APPEAL SUMMARY

Appeal ID: 20546	Project Address: 1600 SW Salmon St
Hearing Date: 6/19/19	Appellant Name: Tom Jaleski
Case No.: B-017	Appellant Phone: 503.488.5651
Appeal Type: Building	Plans Examiner/Inspector: Jody Orrison
Project Type: commercial	Stories: 6 Occupancy: A-2, A-3, B, E, S-1 Construction Type: I-B
Building/Business Name: Lincoln High School	Fire Sprinklers: Yes - Throughout
Appeal Involves: Erection of a new structure	LUR or Permit Application No.:
Plan Submitted Option: pdf [File 1] [File 2]	Proposed use: High School - Main Building

APPEAL INFORMATION SHEET

LINCOLN HIGH SCHOOL REPLACEMENT

100% DESIGN
DEVELOPMENT
STAIR 1 INTERIOR
ELEVATIONS

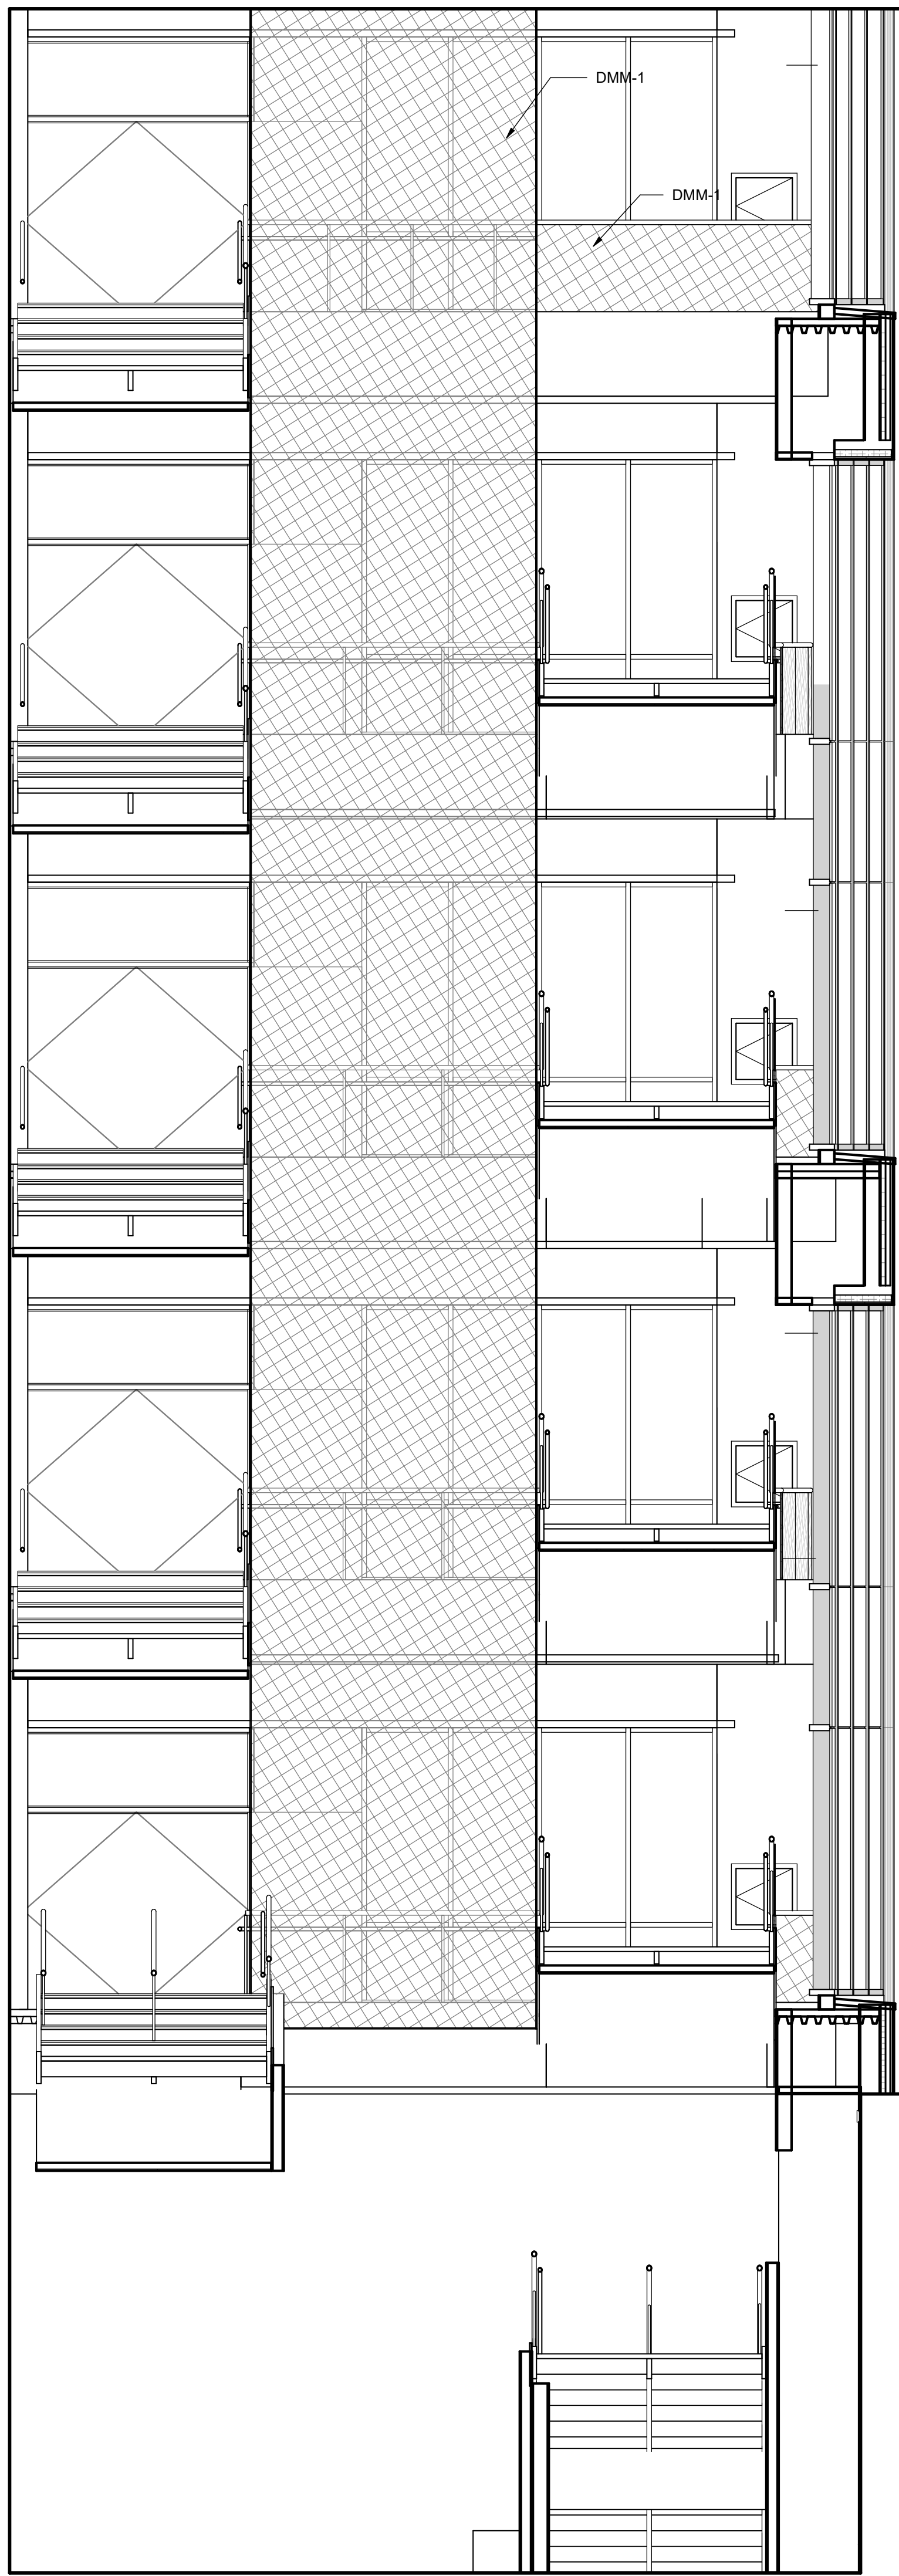
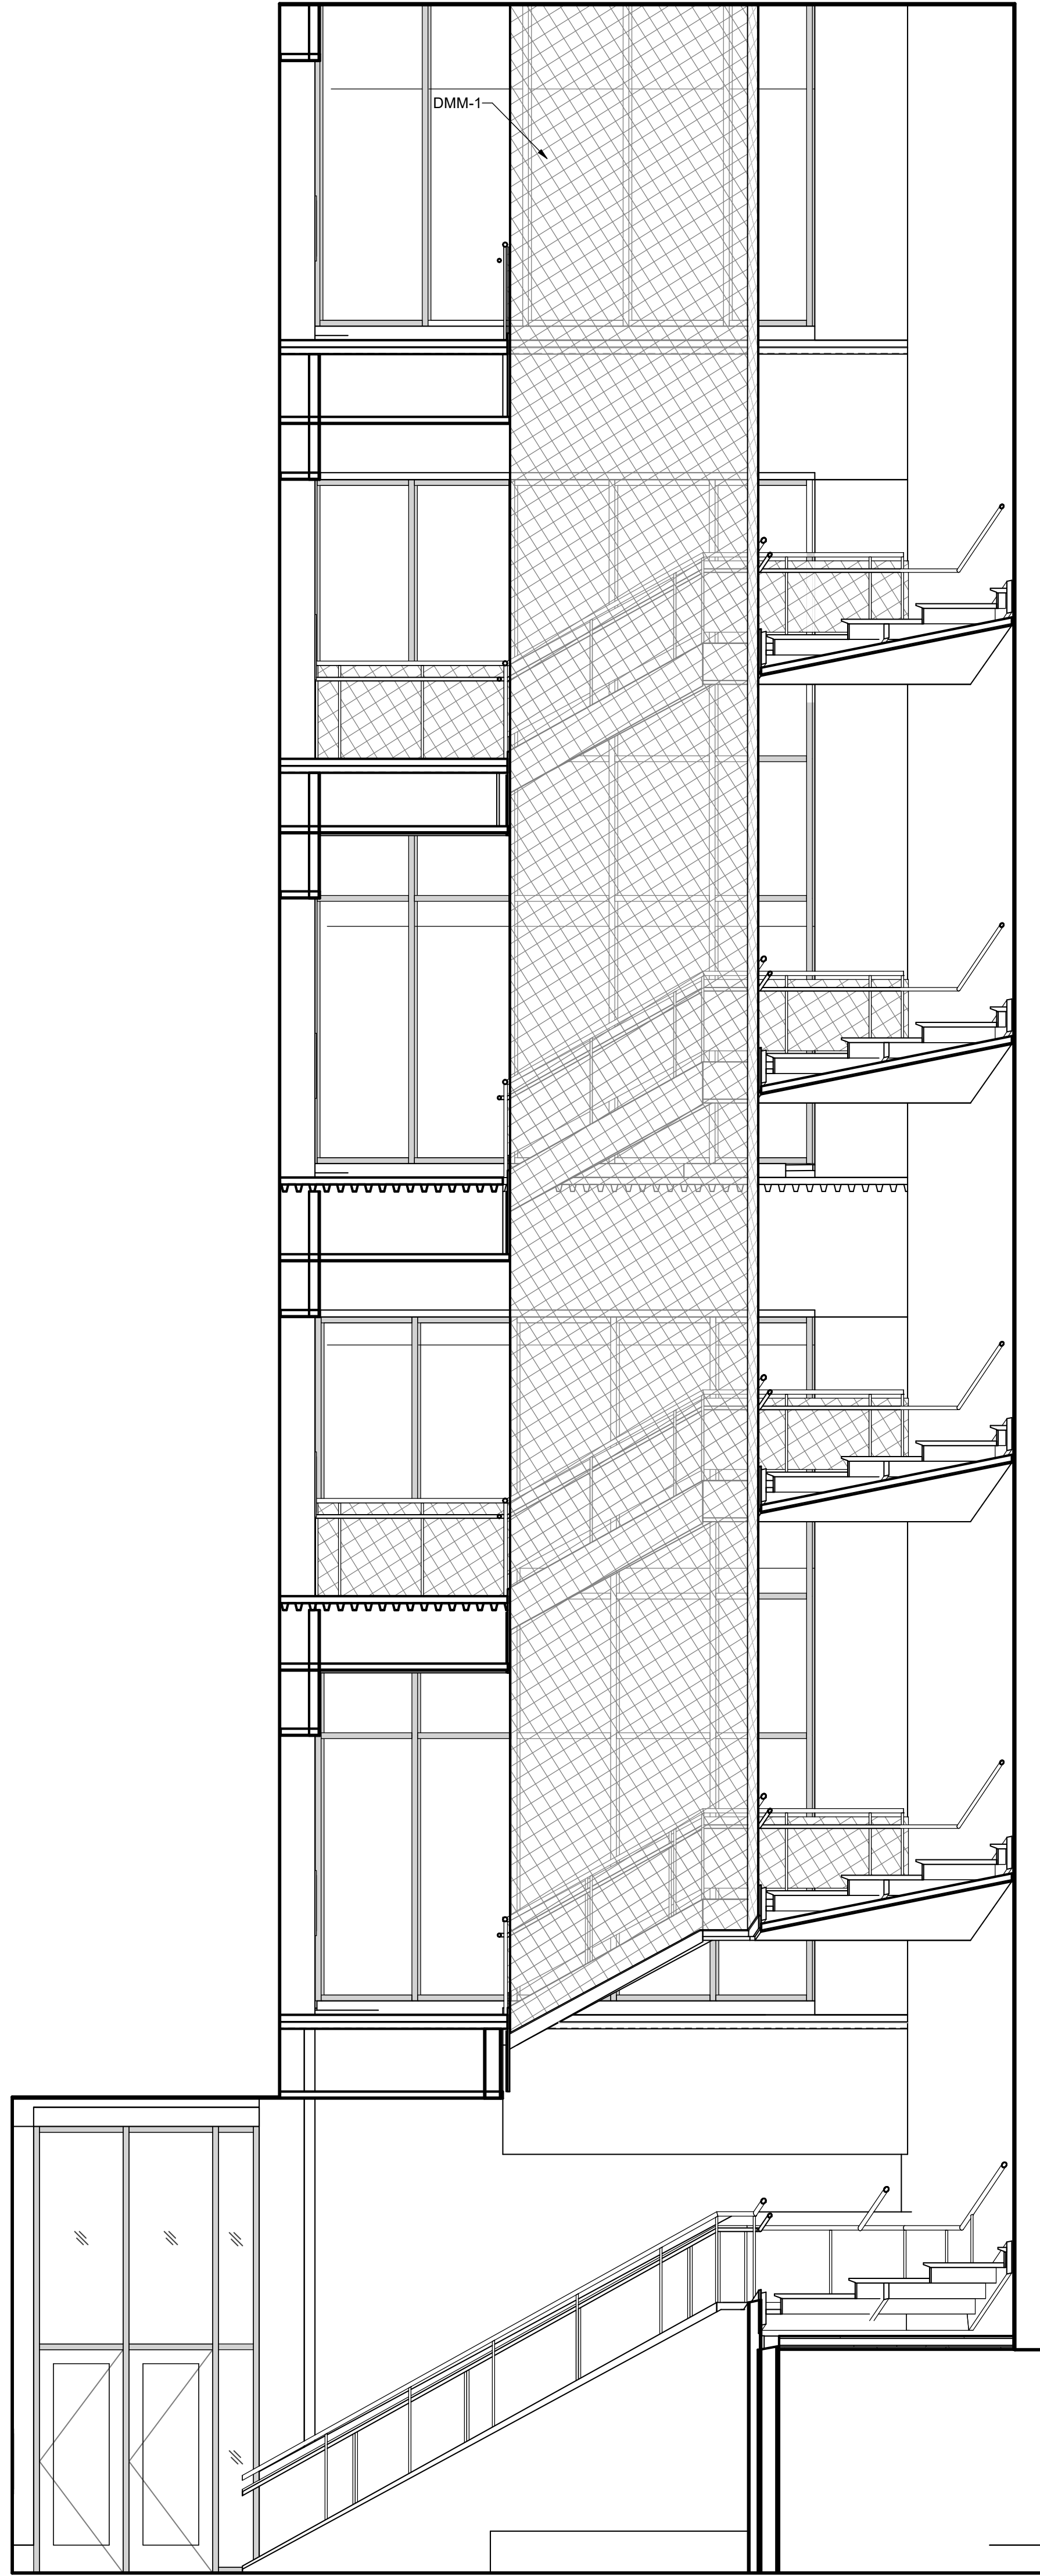
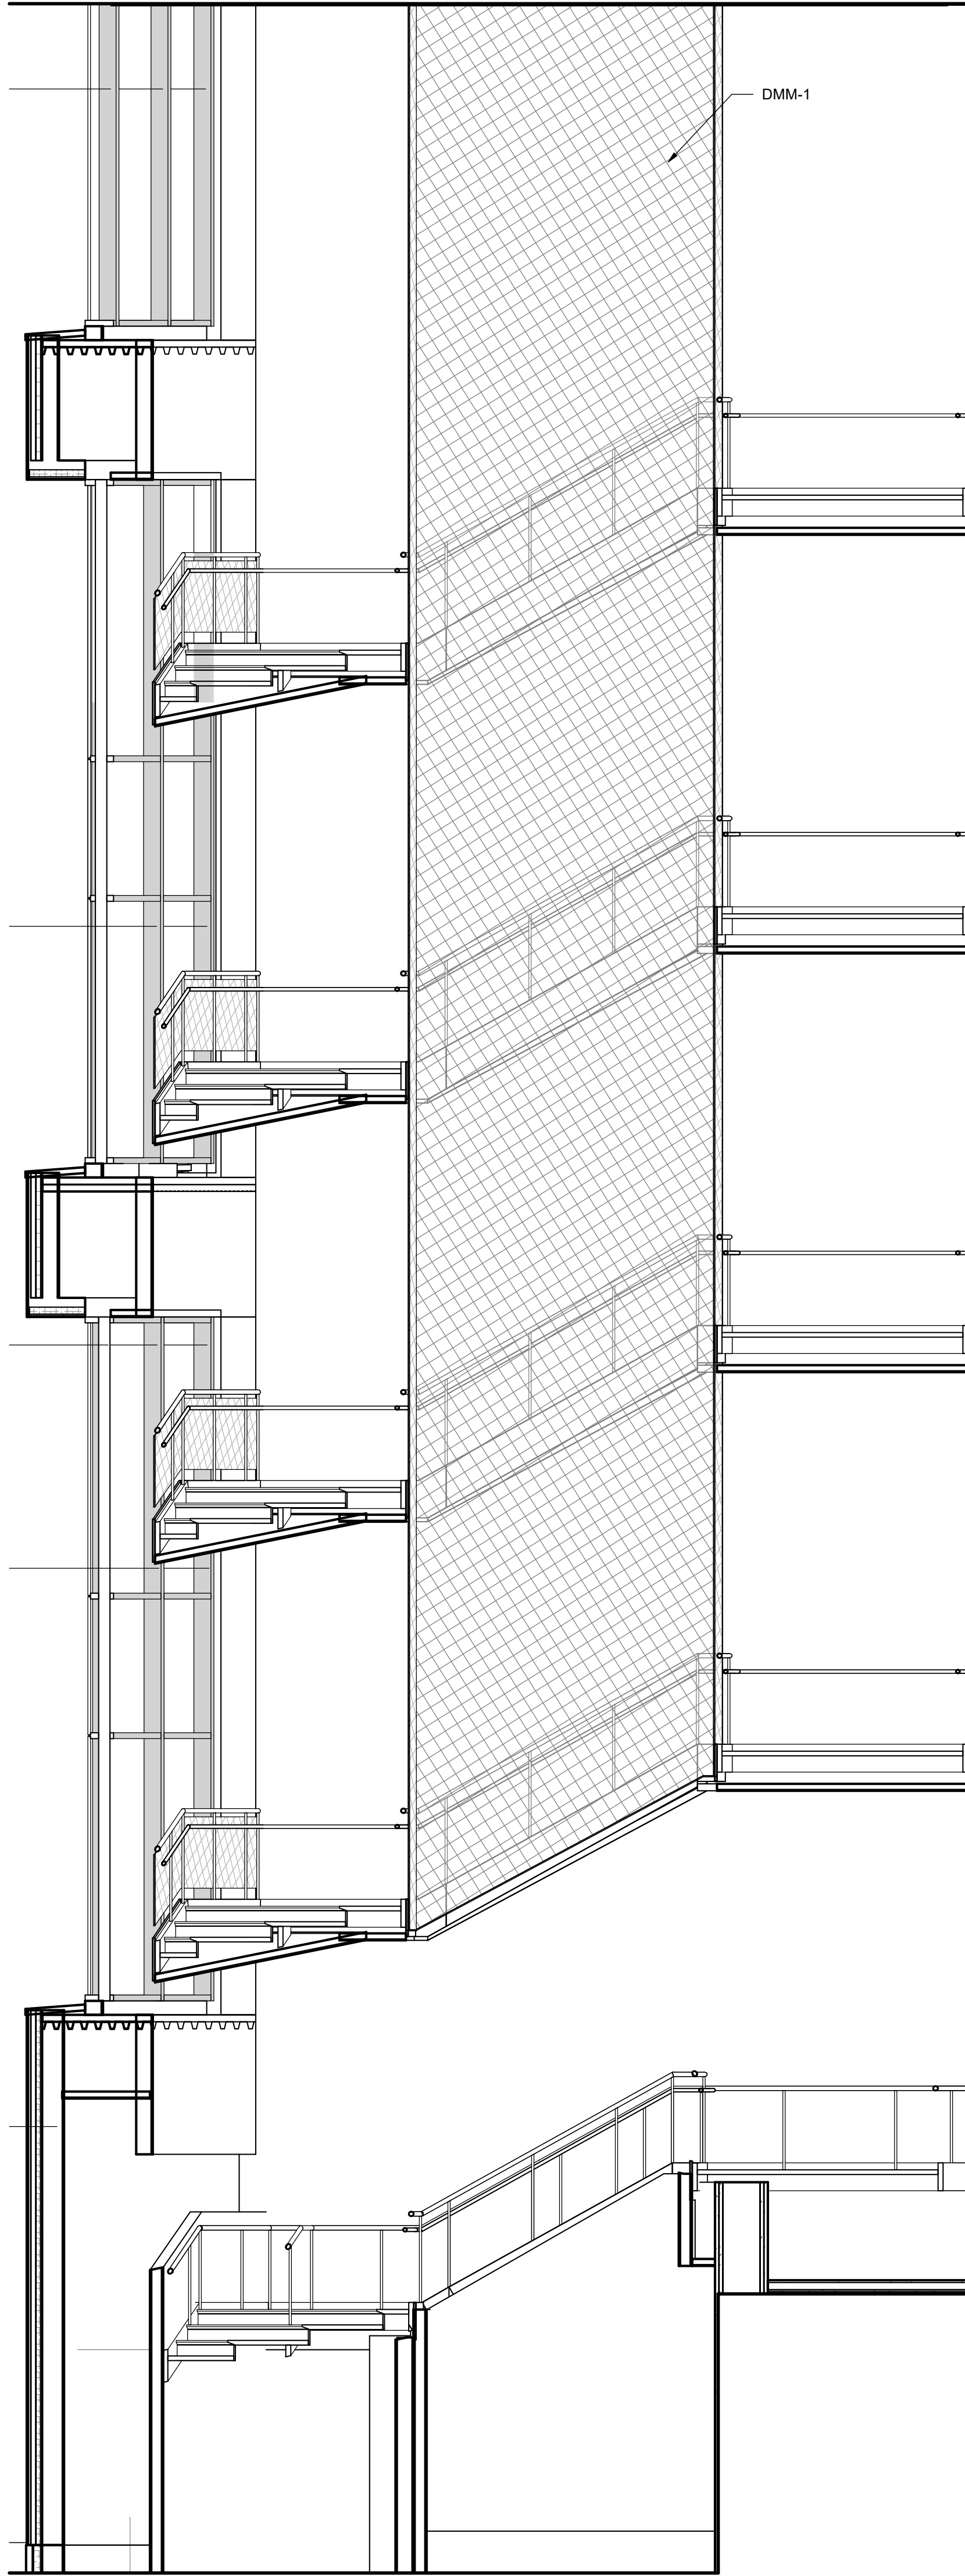
- o Two openings located on west wall of enclosure at Level 01.
- o Each protected with a 3-hour fire shutter meeting UL 10B (equivalent) and UL 1784, and provided with an automatic-closing device and smoke detection.
- o Both shutters are 11-ft wide by 12-ft tall (132 sf).
- o One of the shutters will include a 3-ft wide by 8-ft tall integral person door.

2b. The 3-hour fire-resistance-rated fire shutters located on the west wall of the Stair 4 enclosure and on the west wall of the Stair 1 are not prescriptively allowed. The shutters will provide equivalent fire life safety as compared to the code requirements of a stairway enclosure in a fire event by meeting, and in some requirements exceeding, the opening protective provisions of Chapter 7 as follows:

2. Openings in (2) two hour fire rated stair enclosures: Hold for additional information.
